Proposal to amendment to ECE/TRANS/WP.29/2012/53 (a new Regulation on Child Restraints Systems)

Note: The modifications to ECE/TRANS/WP.29/2012/53 are marked in bold and strikethrough characters.

Annex 7 Appendix 3 – Lateral impact, replace the figure with the following (with new test conditions added):

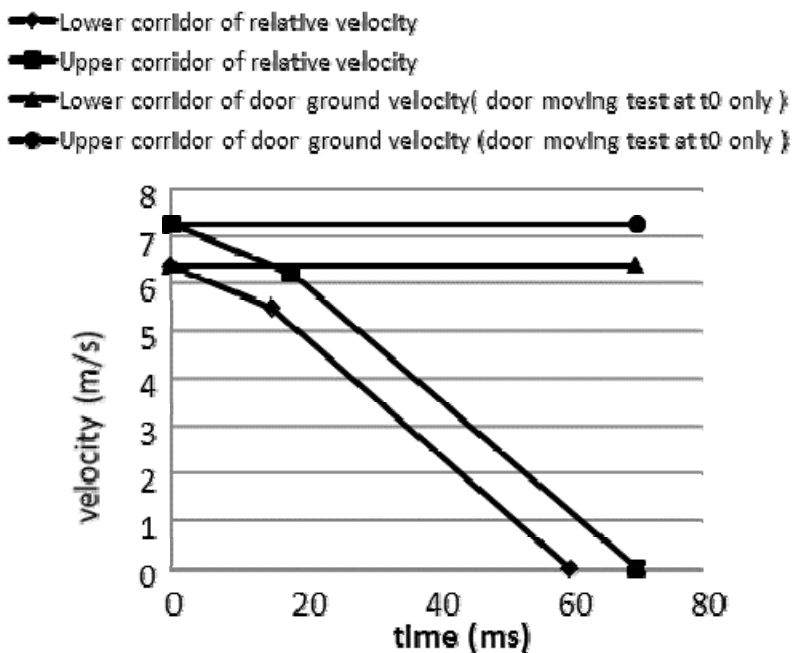
In ECE/TRANS/WP.29/2012/53, a relative velocity between door and seat is defined as the only test condition for lateral impact testing. Such test condition, however, would generate various situations where tests with different stringency levels are possible. For this reason, the new test conditions should be added so that only a single test situation will be generated and the stringency level will be the same between deceleration sled test and acceleration sled test.
